Paycor Stadium Southeast & Southwest VT Escalator Towers
Bid Package 3: Architectural & MEP
ITB#037-26
Addendum 2

May 12, 2026

Addendum 2
Attachment 2

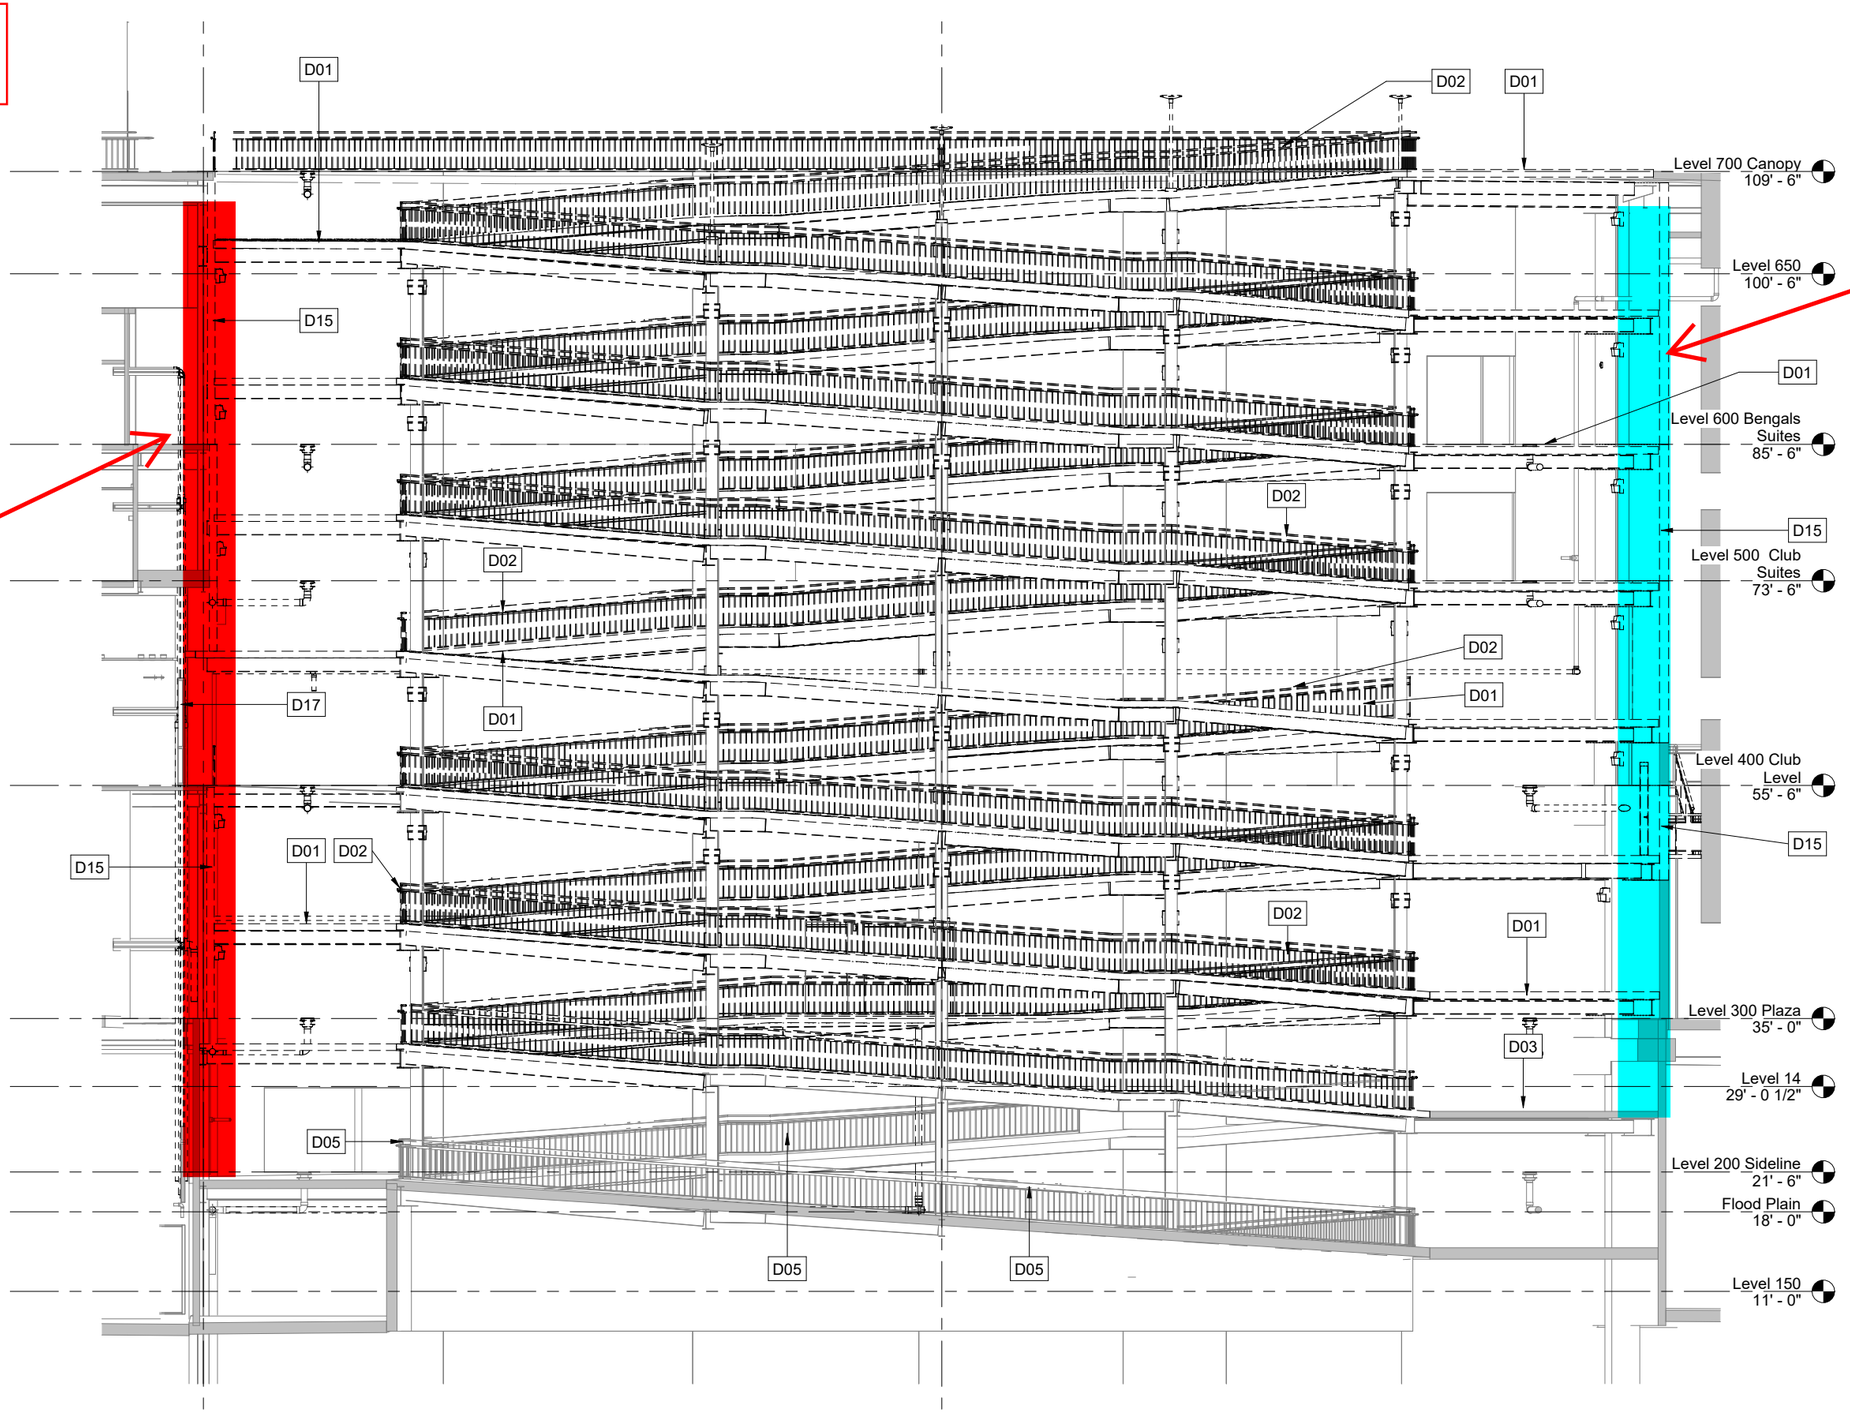
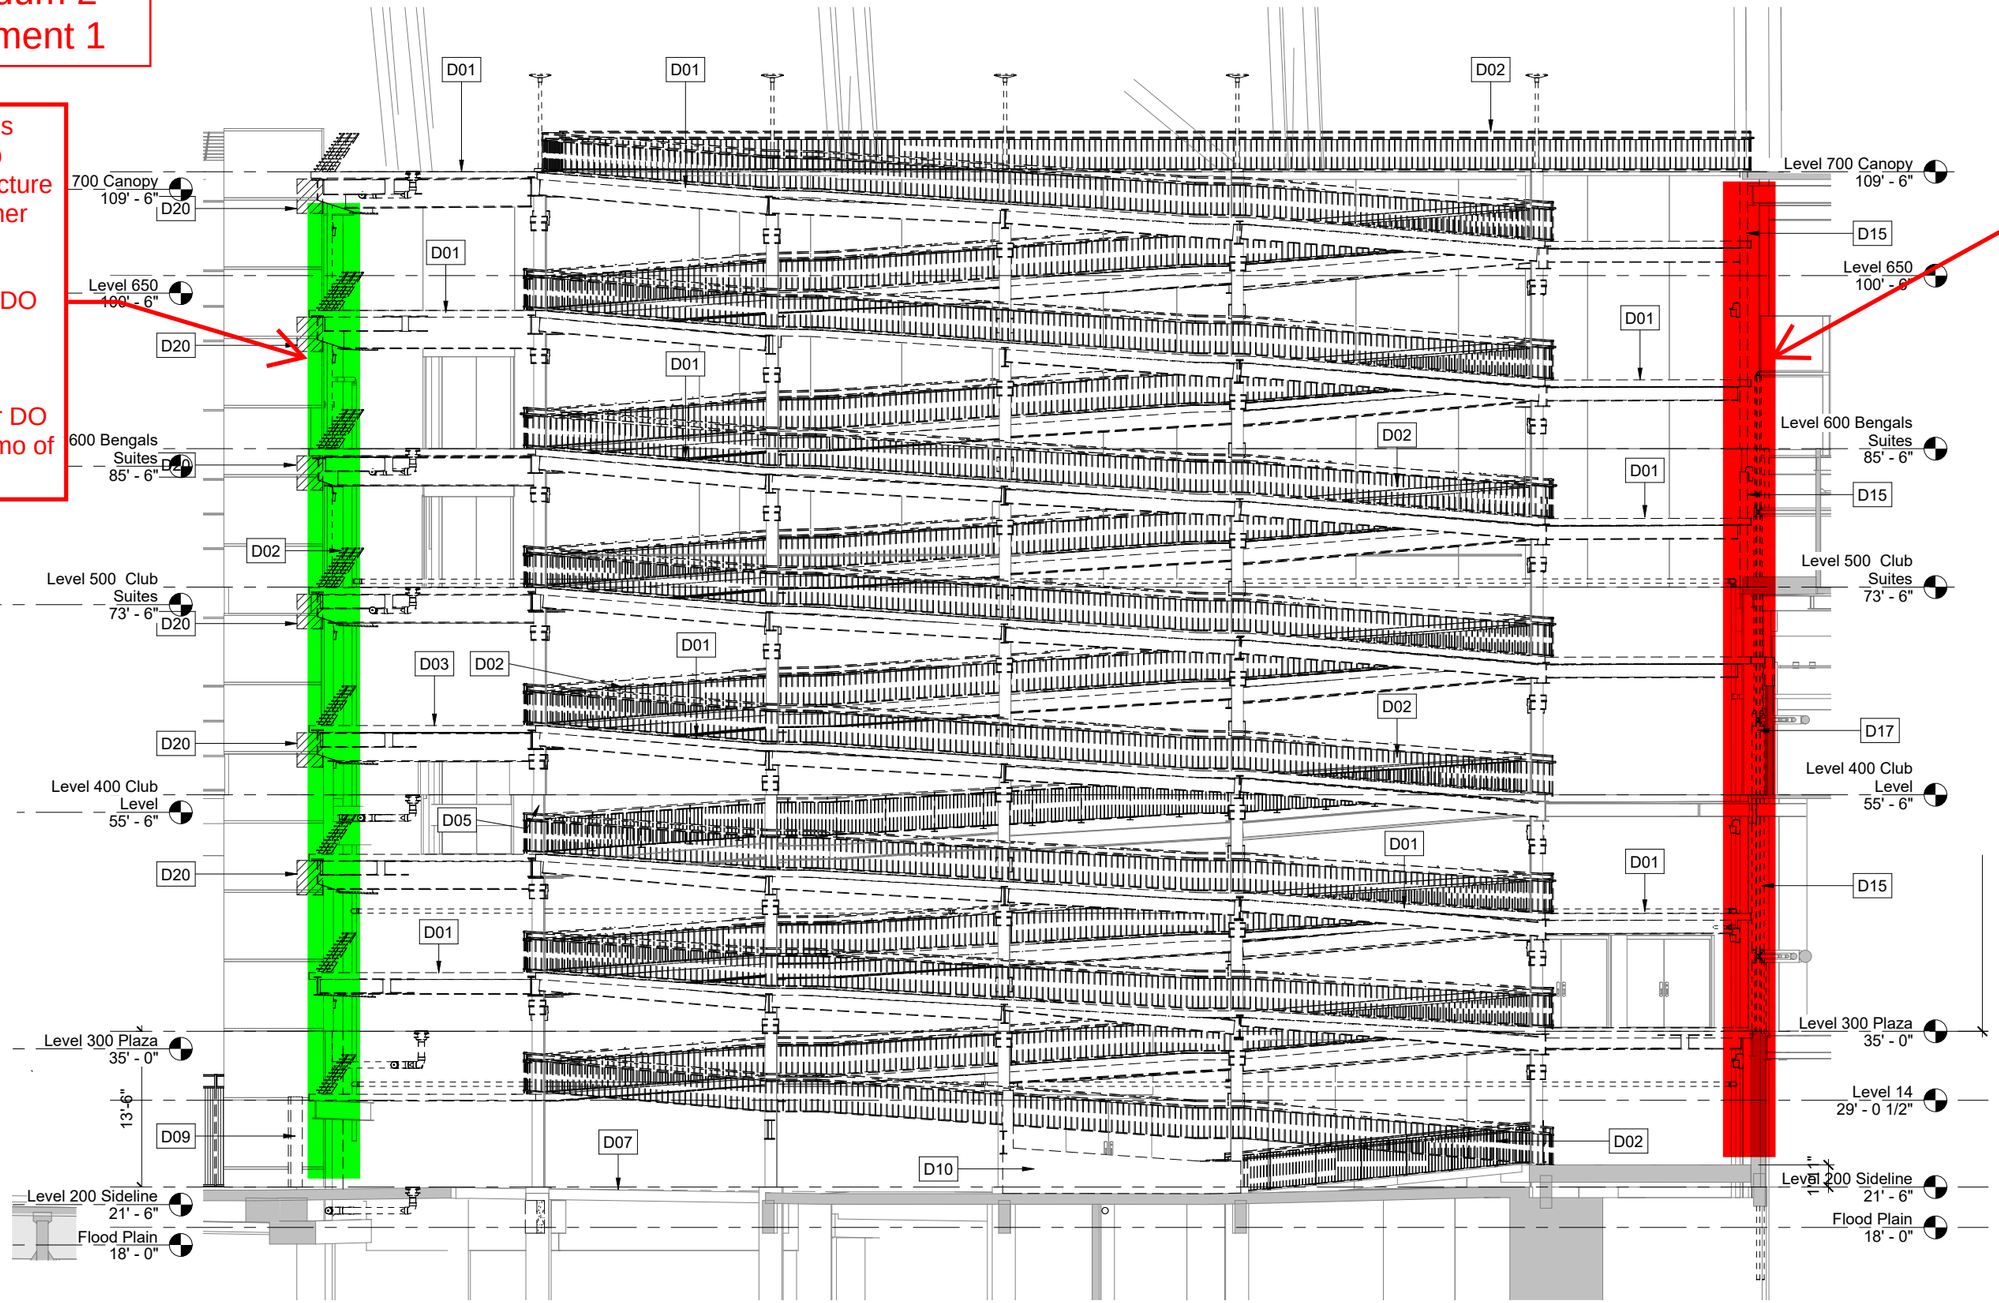
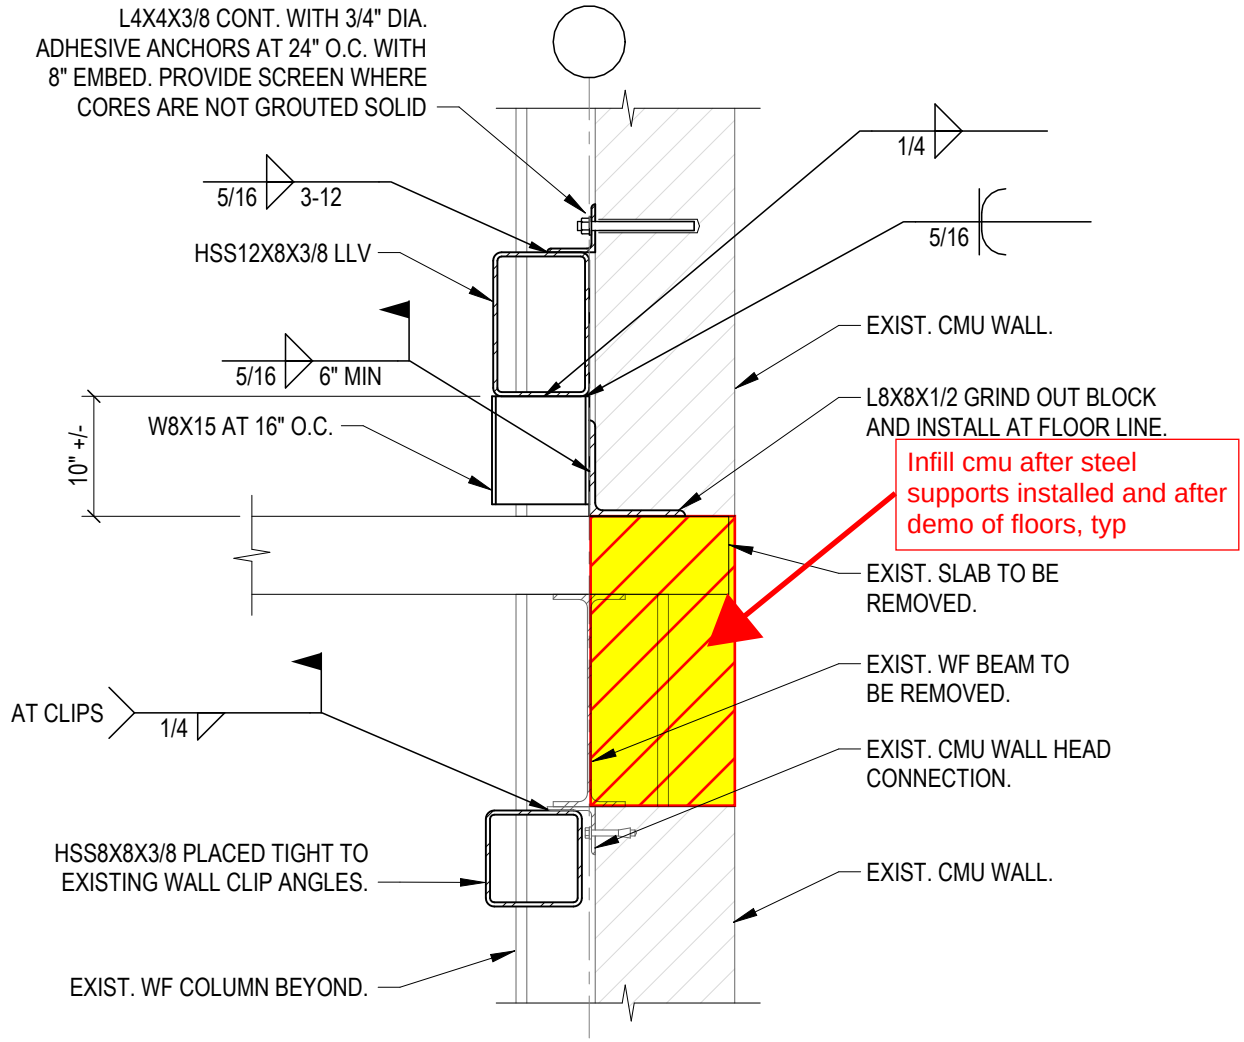
Steel contractor DO NOT include 36/S203 at these locations

Demo Contractor needs to INCLUDE demo of walls at these locations

Light blue CMU walls are able to be saved utilizing 36/S203

Steel contractor DO NOT include 36/S203

Demo contractor DO NOT include demo of CMU walls

Red CMU walls are NOT able to be saved utilizing 36/S203 and will need to be demolished

Steel contractor DO NOT include 36/S203 at these locations

2 A-105.4 **SECTOR 4 - LEVEL 700 NEW WORK ROOF PLAN**
1/8" = 1'-0"

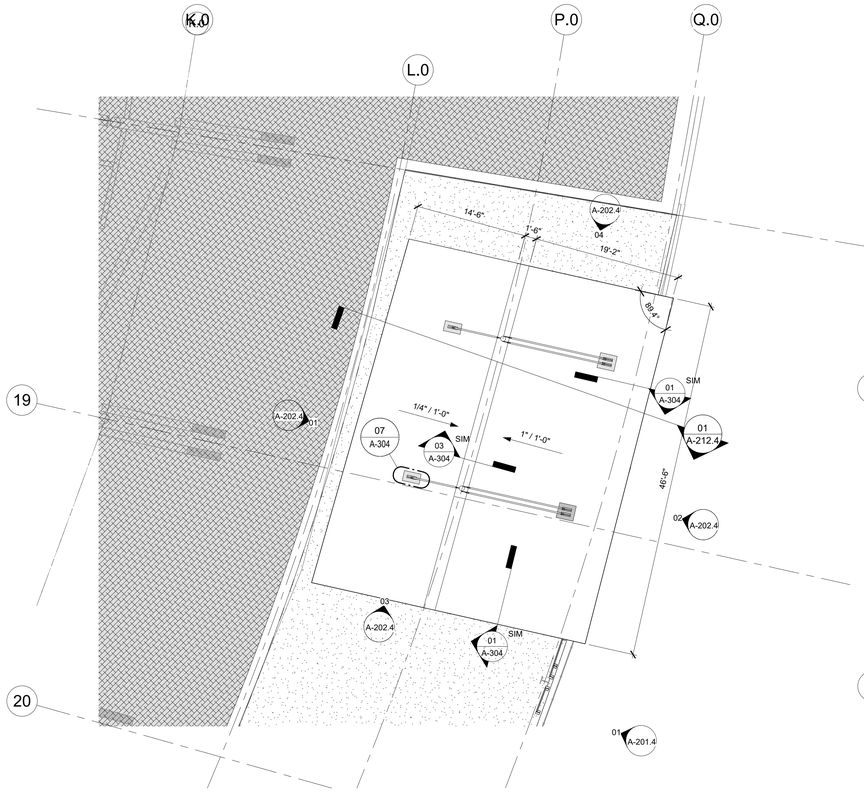
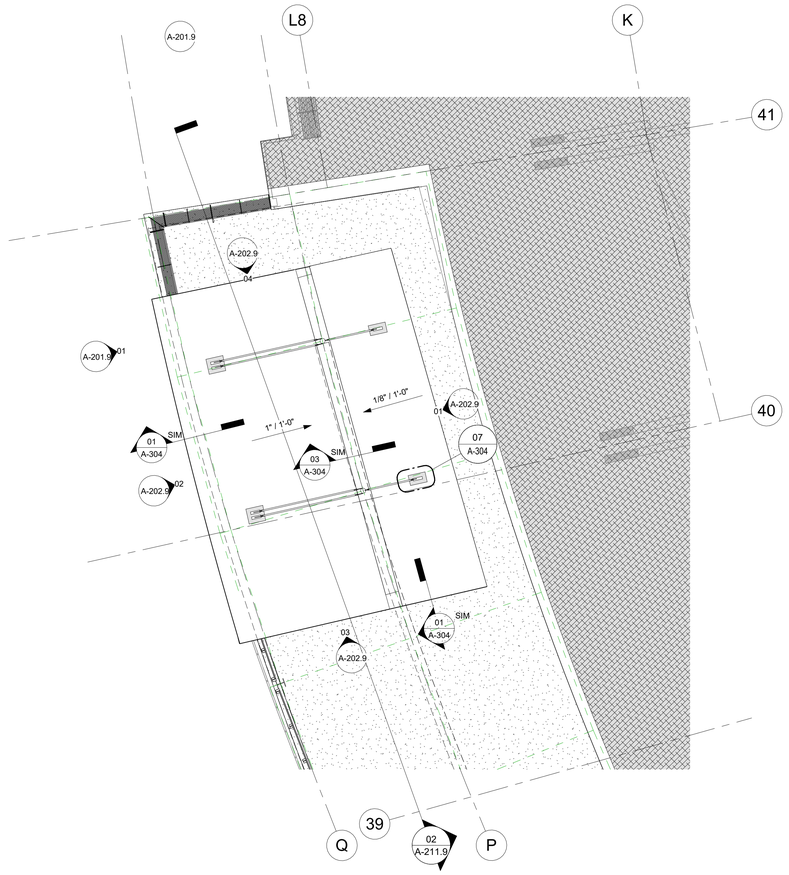
2.4 A105.4, 109.9
- 2.4.1 Section/Detail markers added to Headhouse Roof plan.
- 2.4.2 Revision of drain locations.
- 2.4.3 Addition of concrete control joints.
- 2.4.4 Delineation of 1'-6" Slab hold back at Escalator apron

SECTOR 4 - HEAD HOUSE ELEVATIONS

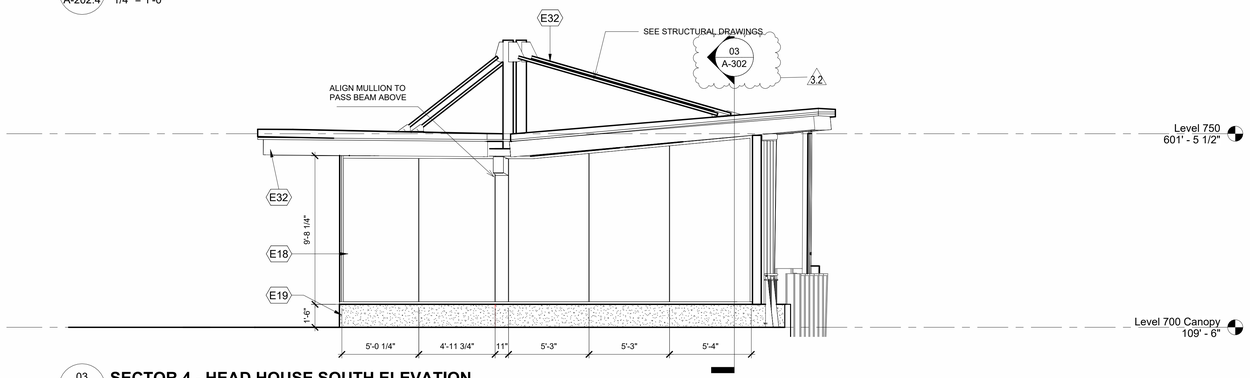
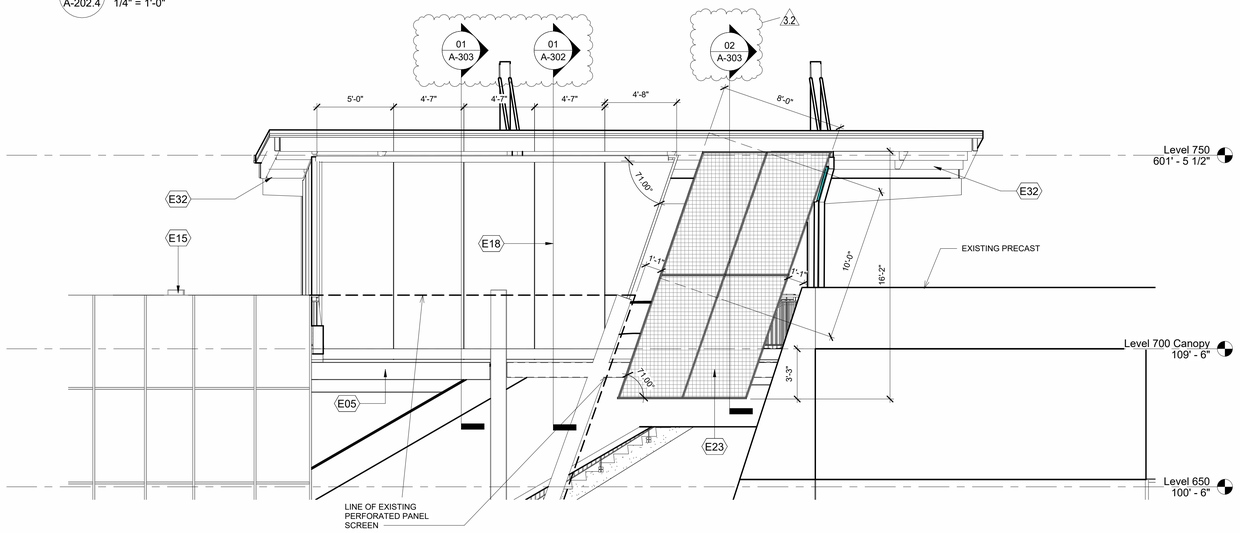
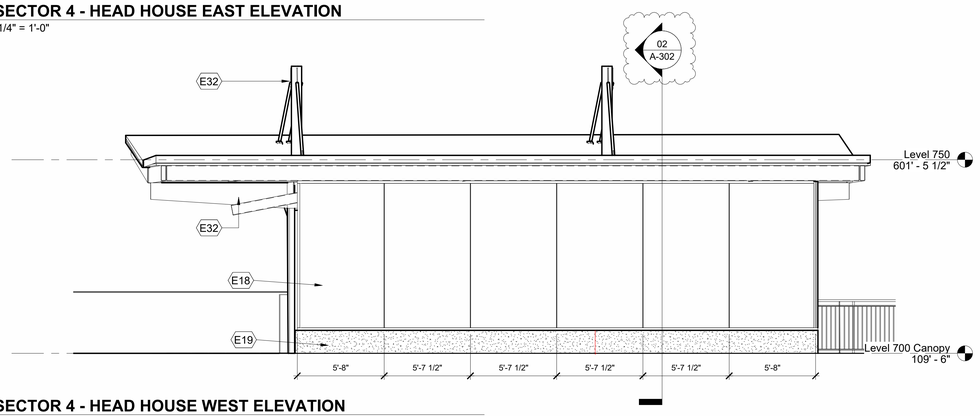
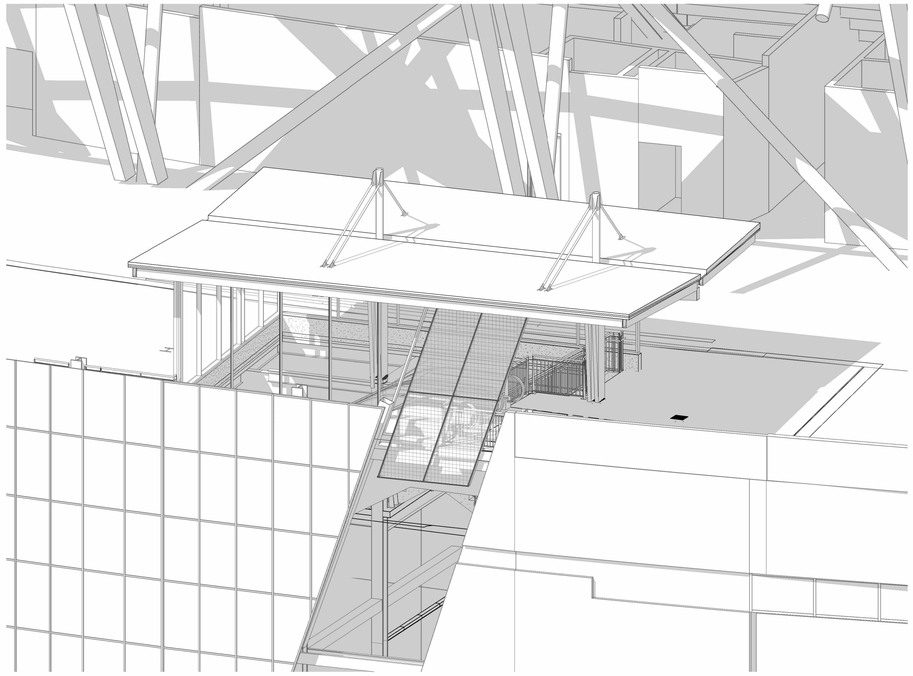
2.5 A-202.4, A-202.9
- 2.5.1 Revision of perforated metal screen
- 2.5.2 Section/Detail markers added to Headhouse Elevations.
